Febru	uary 2, 2018
Emai	l:
Dear	
Re:	Request for Access to Information Under Part II

"Please provide me with all records, including but not limited to, all letters, emails, faxes, notes and other documents, electronic, paper or otherwise, related to civic numbers 12 and 16 Mullock St. St. John's, NL, including but not limited to compliance issues and building applications (permits)."

Mullock 12

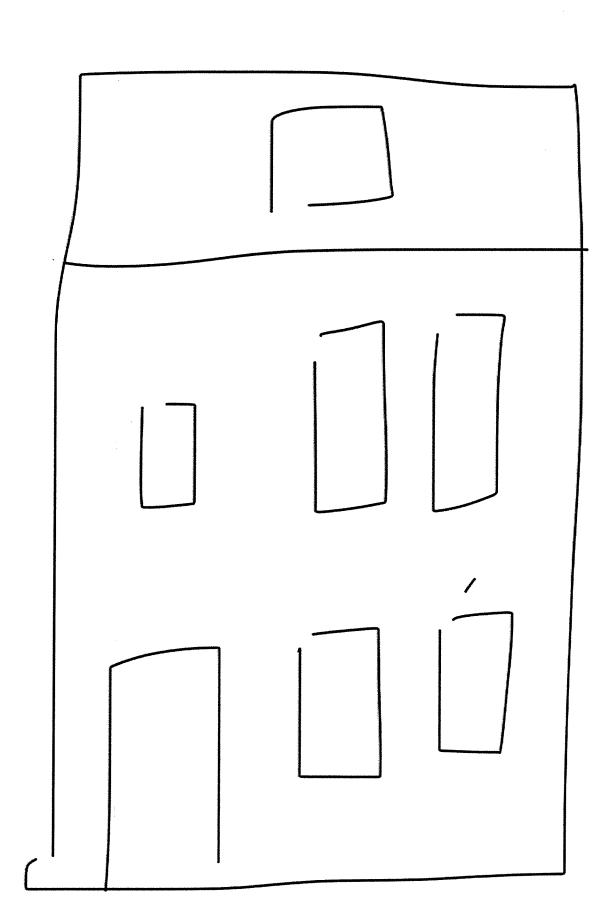
Hi Chris. Have a question on the front windows	2016/10/25 12:22:19 PM
From: To: Date:	"crice@stjohns.ca" <crice@stjohns.ca> 2016/10/25 12:22 PM</crice@stjohns.ca>	
Subject:	Mullock

Hi Chris. Have a question on the front windows. We have to make bedroom window meet egress and the wall has been a little hacked up by previous owner. It looks like it'll be easier to do two smaller windows in living room and in bedroom above. Is this ok to do as long as they're in line with each other and single hung? As in sketch below

Front porch - 12 Mullock

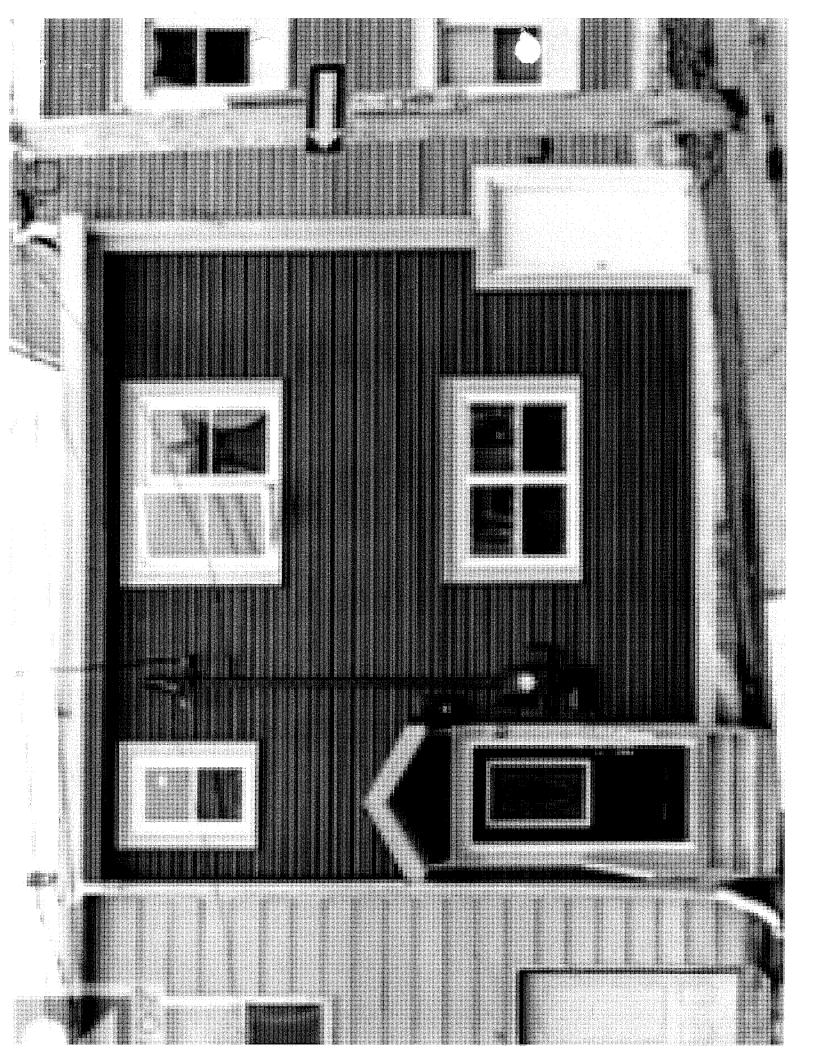
Hi Cliff - we are planning on removing the Front porch. I think there is problems underneath that may not be worth keeping. I just wanted to have it put on the file. Attached is a sample picture of what we want to do at the front

MAIN FLOOR

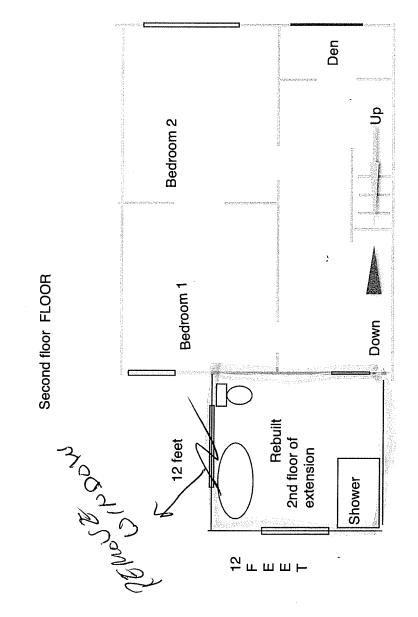
-> Siding to be Renewed. 5/8° Barro Dastalled a Vigyh. Soling Pustelled
